SEWAGE DISPOSAL SYSTEM
HOWARD COUNTY HEALTH DEPARTMENT
BUREAU OF ENVIRONMENTAL HEALTH
410-313-2640

PROJECT: LOT 2 PLAT 14467
CARWITHEN PROPERTY
WOLFREY RESIDENCE
1853 LONG CORNER ROAD
MT. ARY, MARYLAND 21771

TITLE: Sand Mound Design Plan
SITE PLAN

TITLE: SAND MOUND DESIGN PLAN

SHEET: **C-1**
PAGE: 1 OF 3

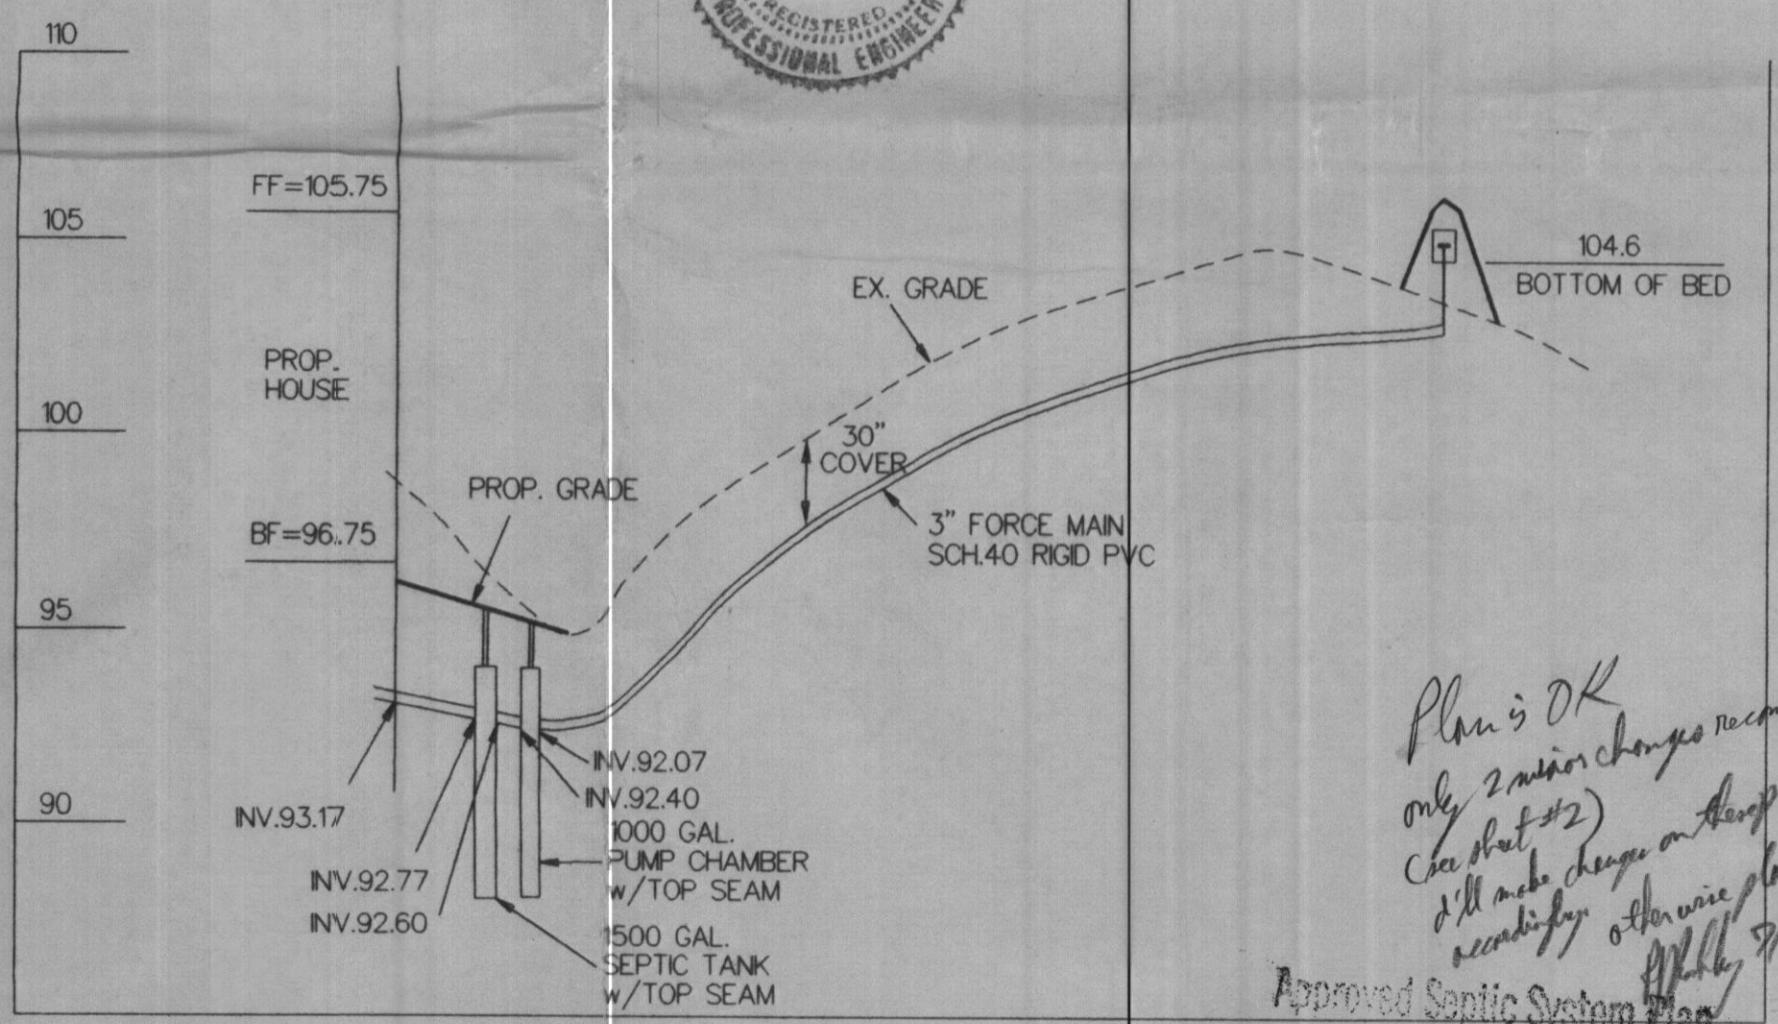
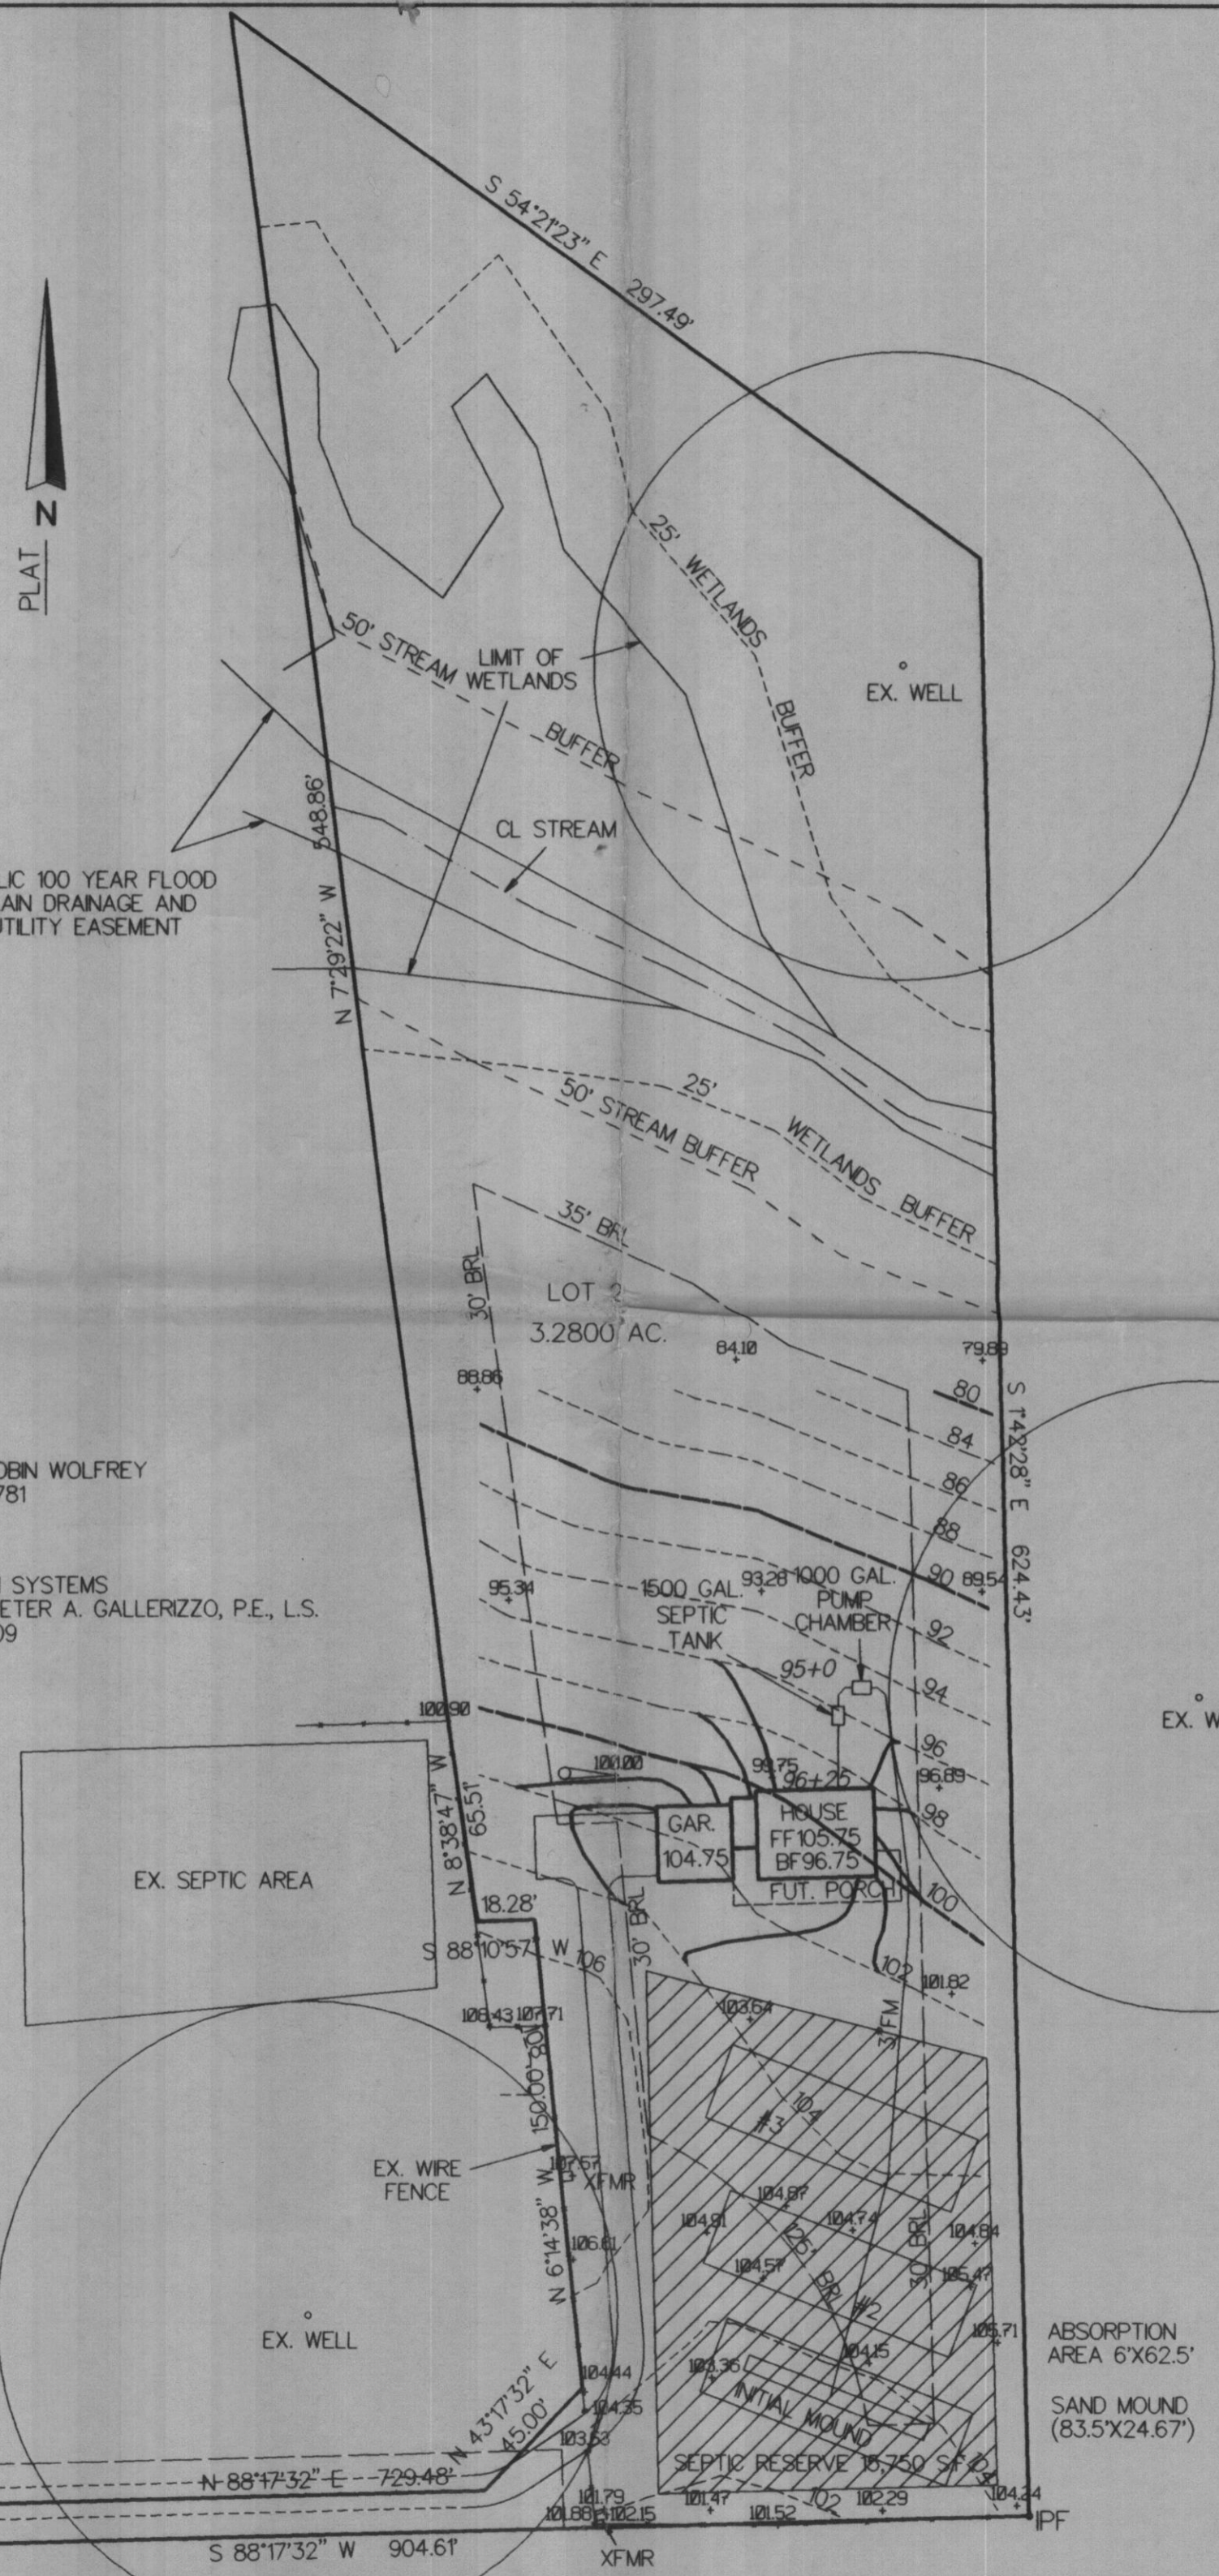
Plan is OK only 2 minor changes recommended (see sheet #12) I'll make changes on the plans accordingly after we plan is approved. P. Gallerizzo 7/10/01

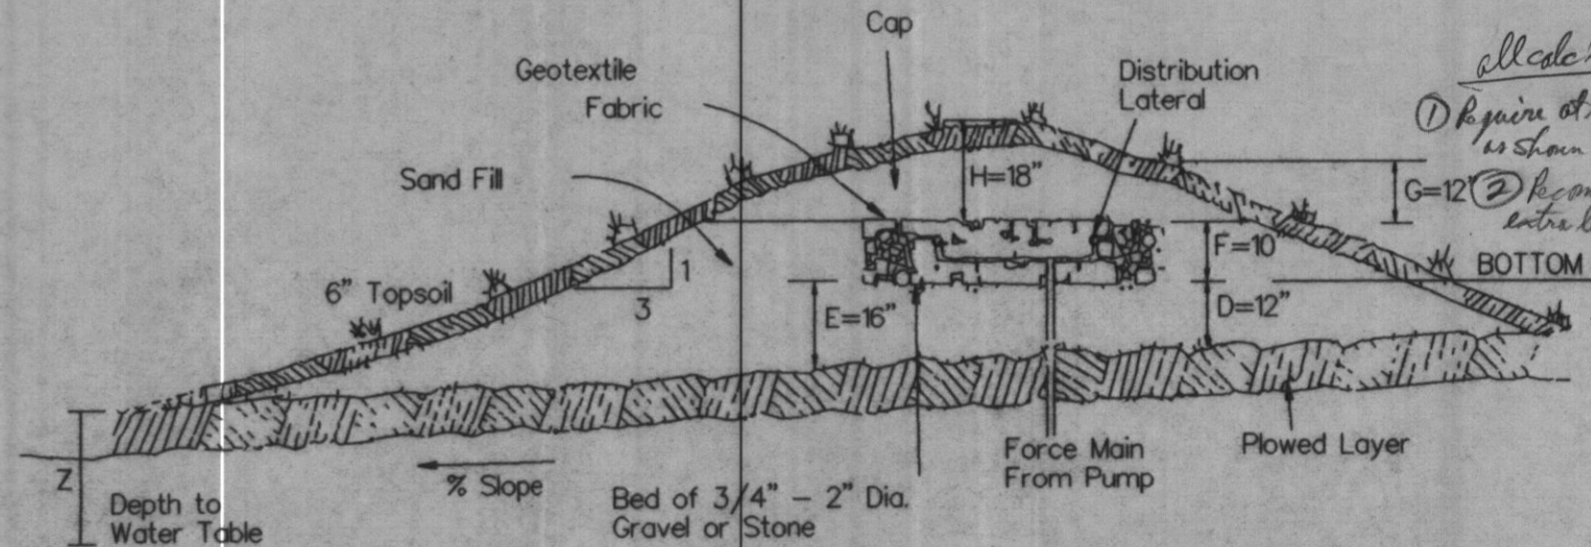
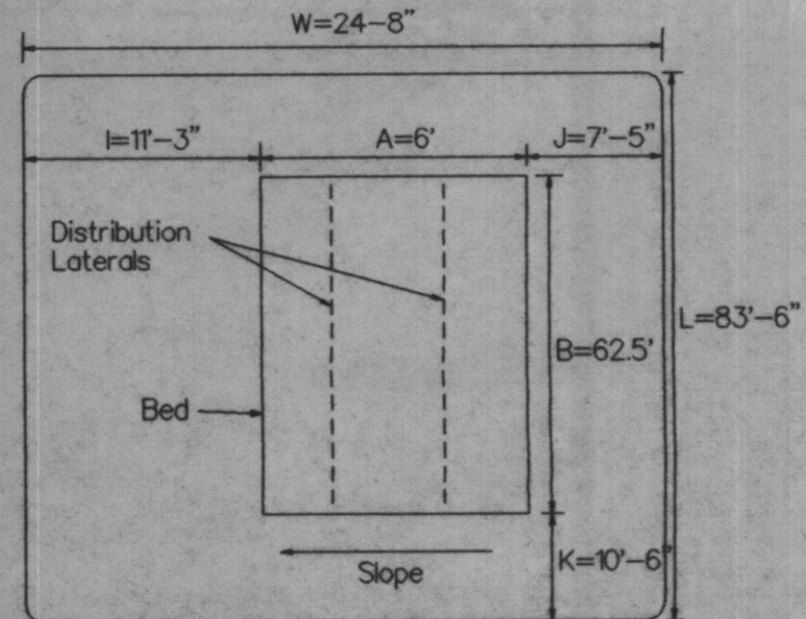
If you prefer you may cut off the 1/4" stub of lateral at the seventh lateral perforation
 Use central fed manifold distribution network *preferred*
 length of bed = 62.5'
 length of lateral = $(62.5 - 1) / 2 = 30.75'$
 width of bed = 6' use 2 rows of laterals
 distance between laterals = $6 / 2 = 3'$
 use 5/16" dia. perforation
 spacing of perforation = 42" o.c.
 use 1-1/4" dia. laterals (table) $23 < 30.75 < 36$
 number of perforations per lateral = $0.5 \times 62.5 / 3.5 = 9$
 distance between manifold and first perforation
 $\frac{(0.5 \times 62.5) - [(9 - 1) \times 3.5]}{2} = 1'-7 1/2"$

SHEET: **C-3**
 PAGE: 3 OF 3

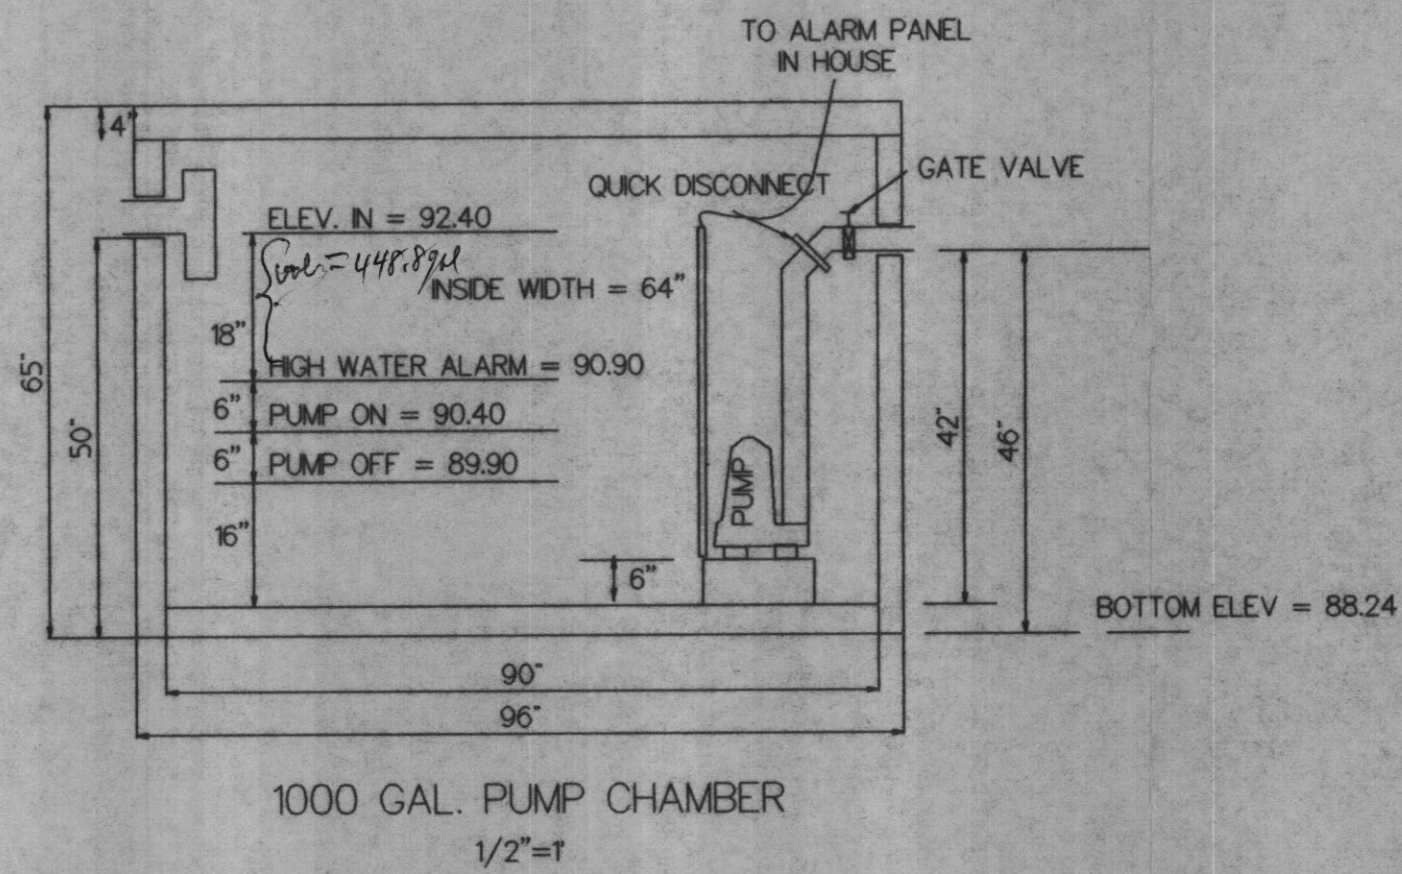
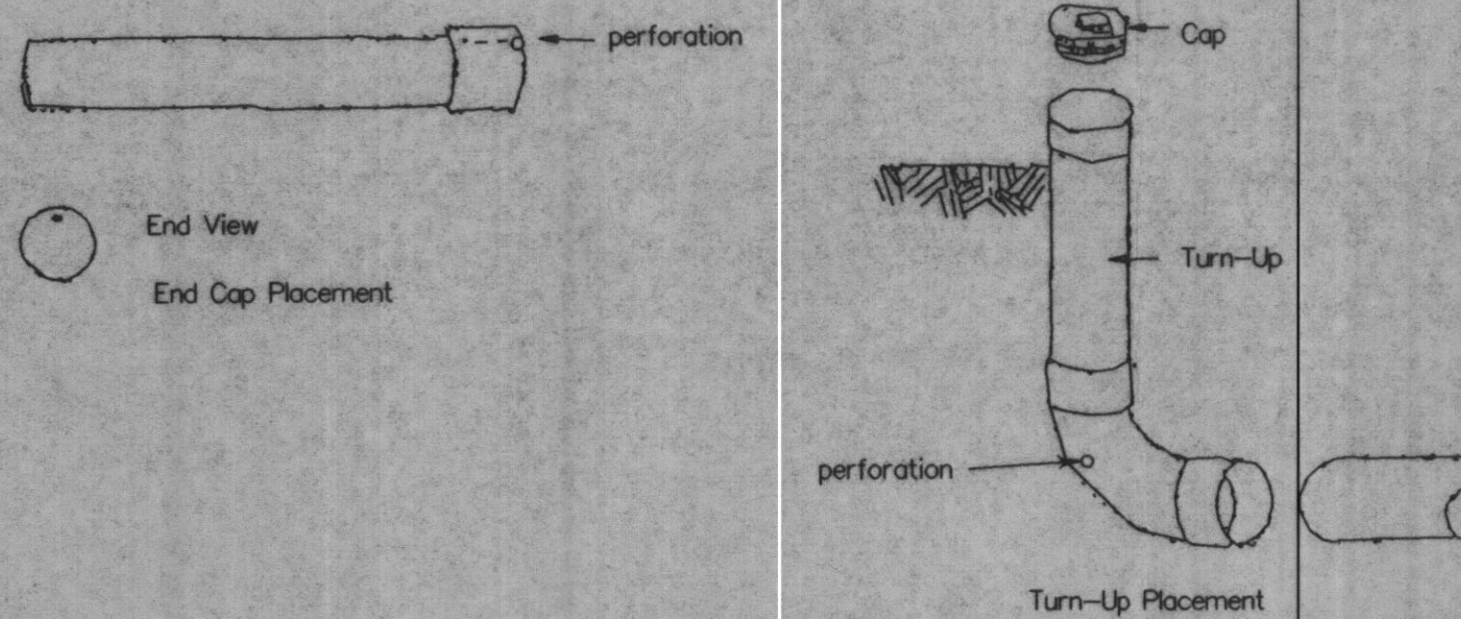
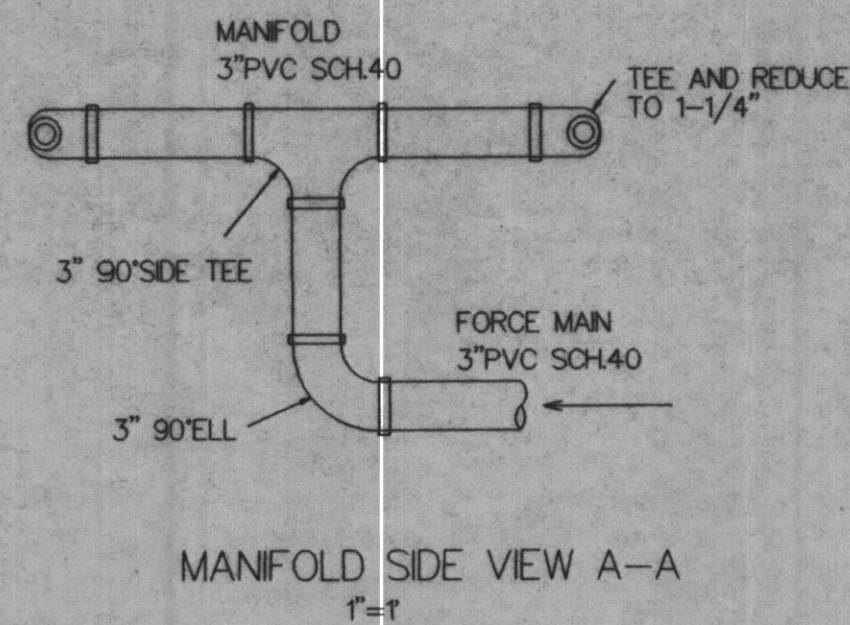
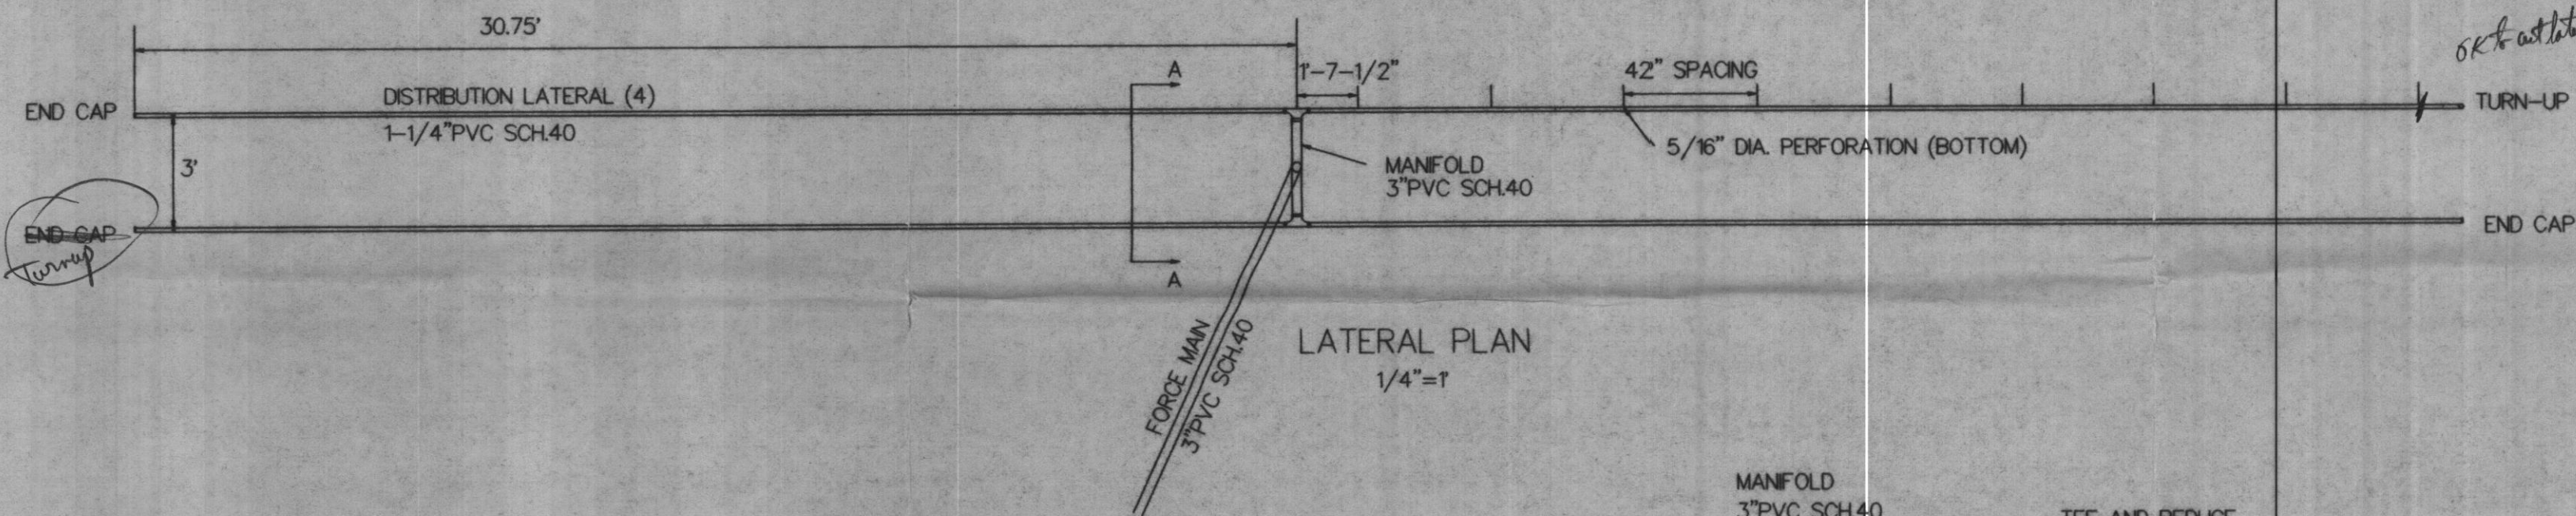
OK to cut lateral at last perforation
